BID
ADDENDUM NO. 3
TO
CONTRACT DOCUMENTS
AND
TECHNICAL SPECIFICATIONS
FOR
2019 BOND REFERENDUM
CAPITAL IMPROVEMENTS
AT
MAMARONECK HIGH SCHOOL
PHASE 2
NYSED #66-07-01-03-0-001-039
BID # 20/21 – MUFSD-00

Mamaroneck Union Free School District
1000 West Boston Post Road
Mamaroneck, NY 10543

LAN Job #4.1092.72.06
January 7, 2022

NYSED PROJECT # 66-07-01-03-0-001-039
WORK AREAS A & B: STEAM LAB & CULINARY ARTS FIRE ALARM PLANS
CAPITAL IMPROVEMENTS AT MAMARONECK HIGH SCHOOL
MAMARONECK UNION FREE SCHOOL DISTRICT
1000 BOSTON POST ROAD, MAMARONECK, NY 10543
Job No. 4.1092.72.6
File No. 10927206E510
FA2.10

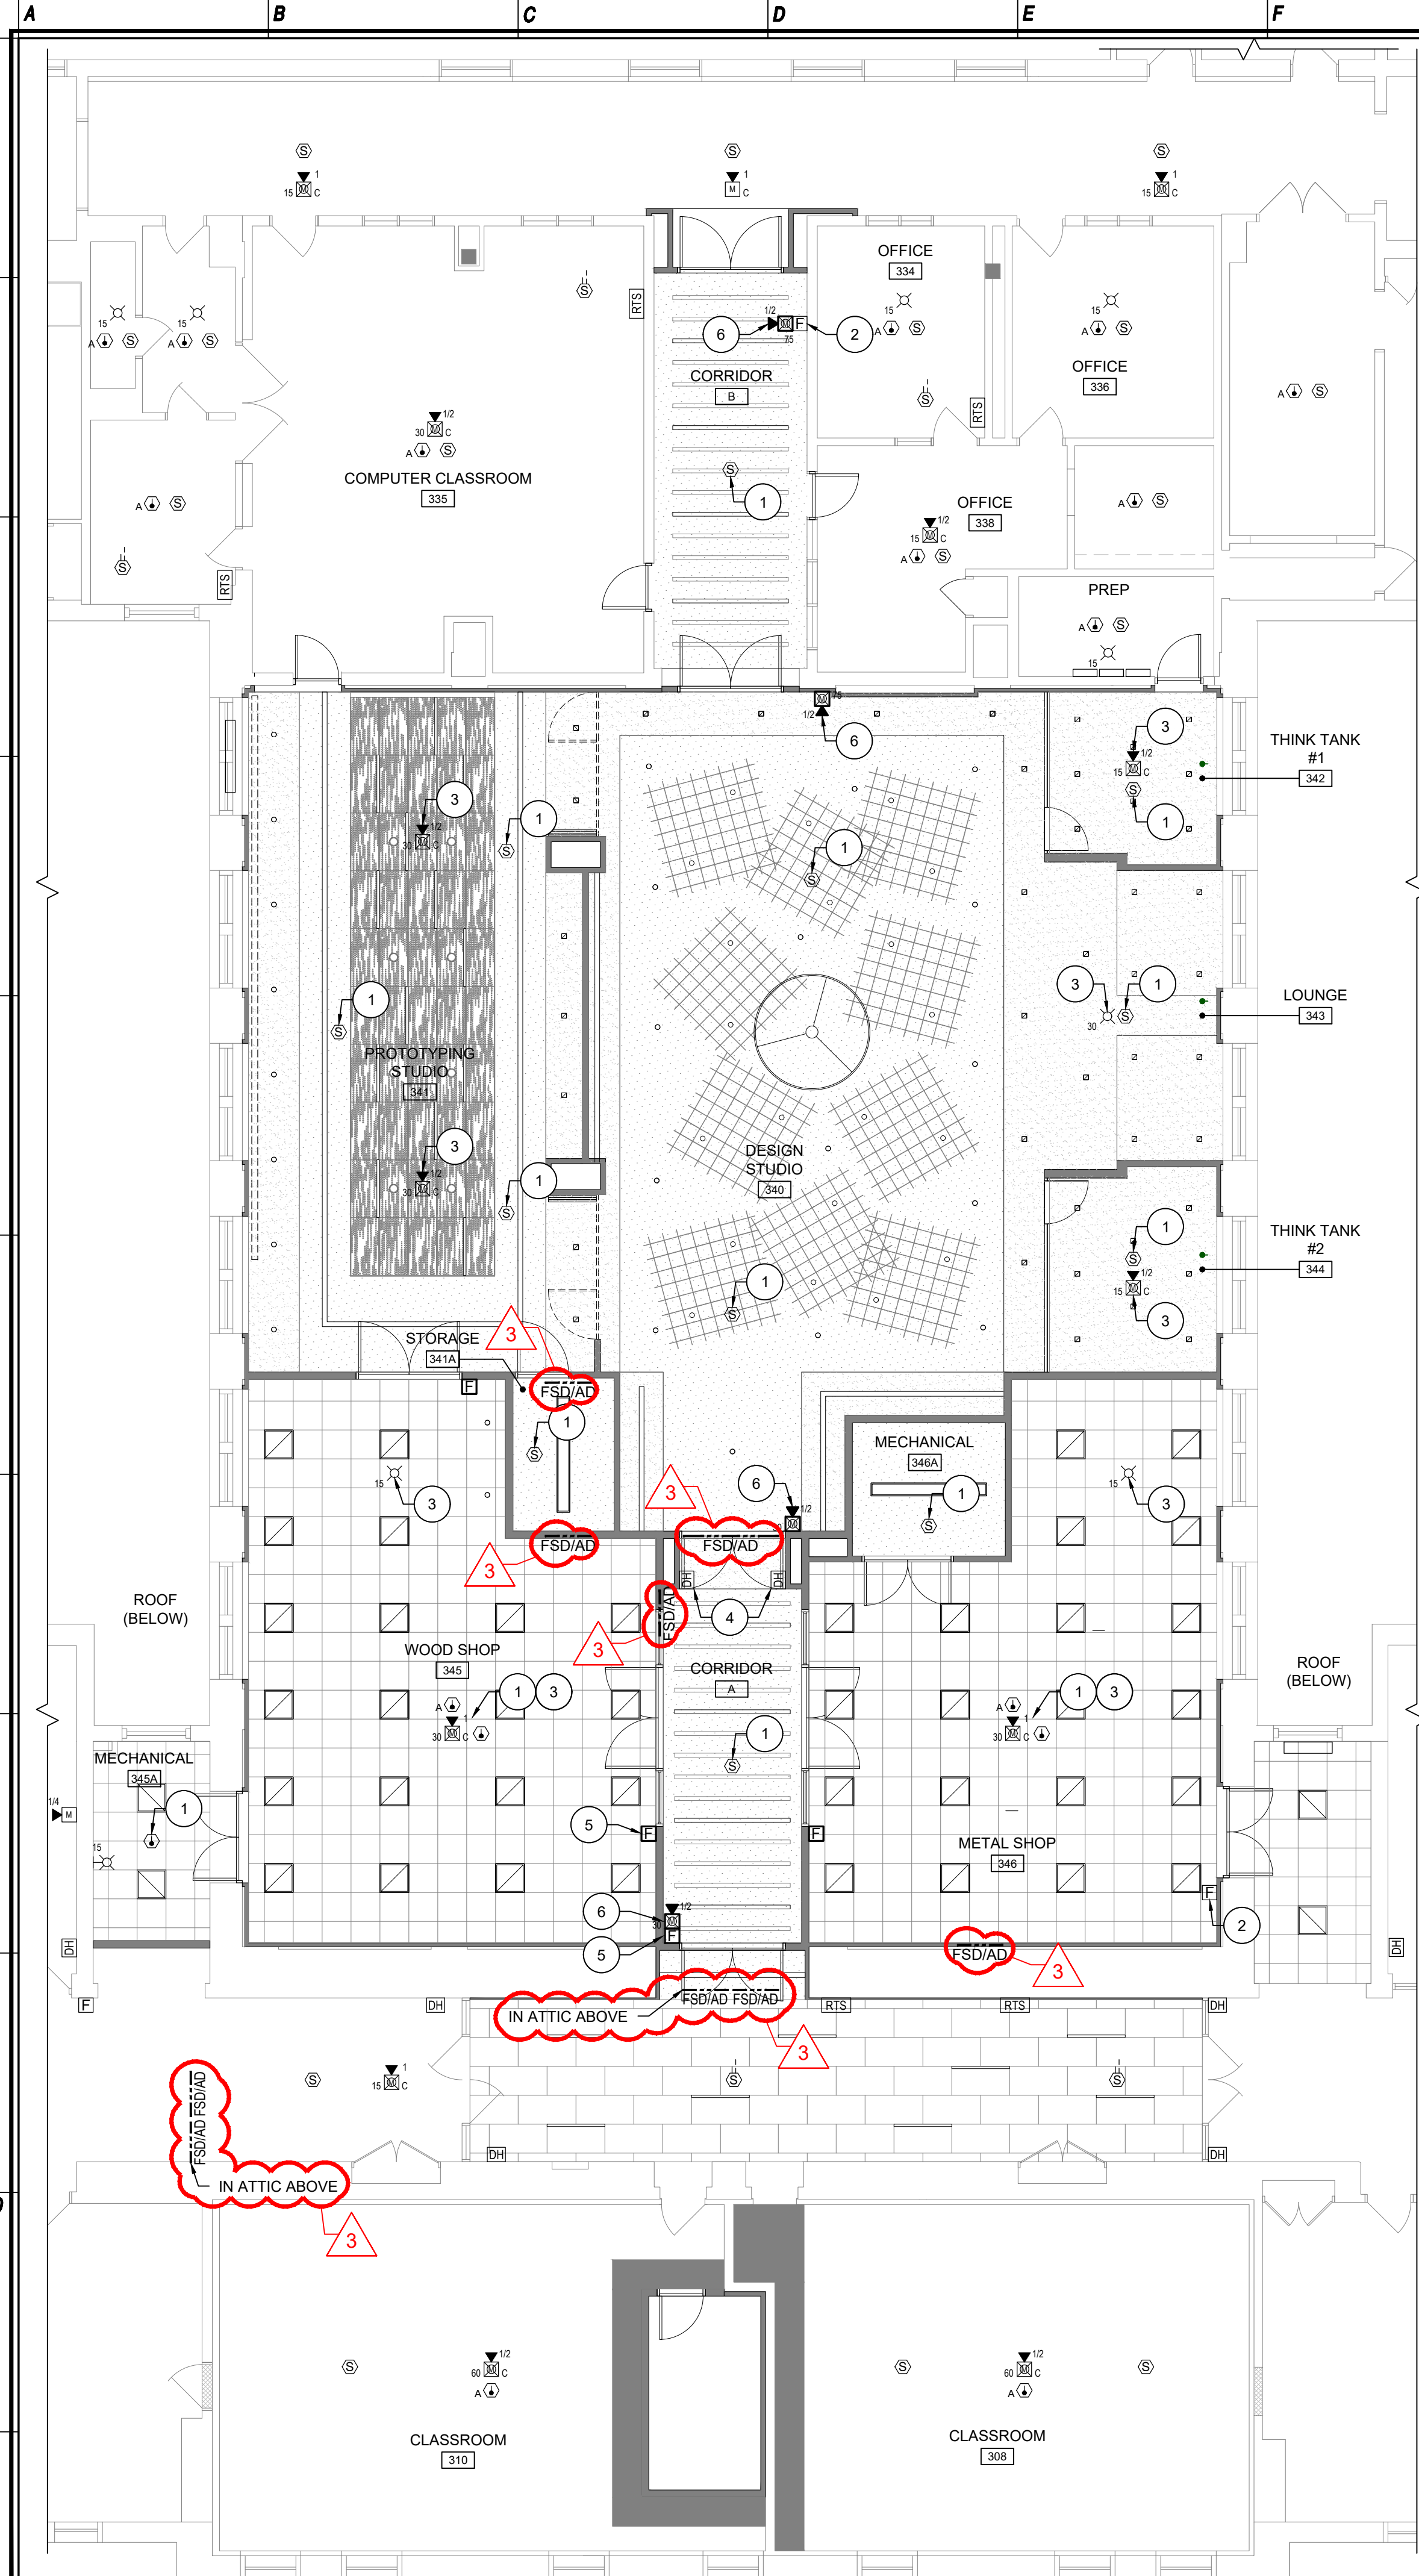
| 10 | <p>Question: The symbol legend shown on drawing FA2.10 shows a corresponding Key Note # for each device that has some work revolving around it, whether the device is new or existing to be relocated. And it shows a number of devices that are existing to remain with somewhat dim or light lines. Please confirm that all devices without a corresponding Key Note # are intended to be existing to remain.</p> <p>Response: Yes, all light line devices without Key Notes are existing to remain. Refer to the Symbol Legend in the top right portion of the drawing for additional information.</p> |
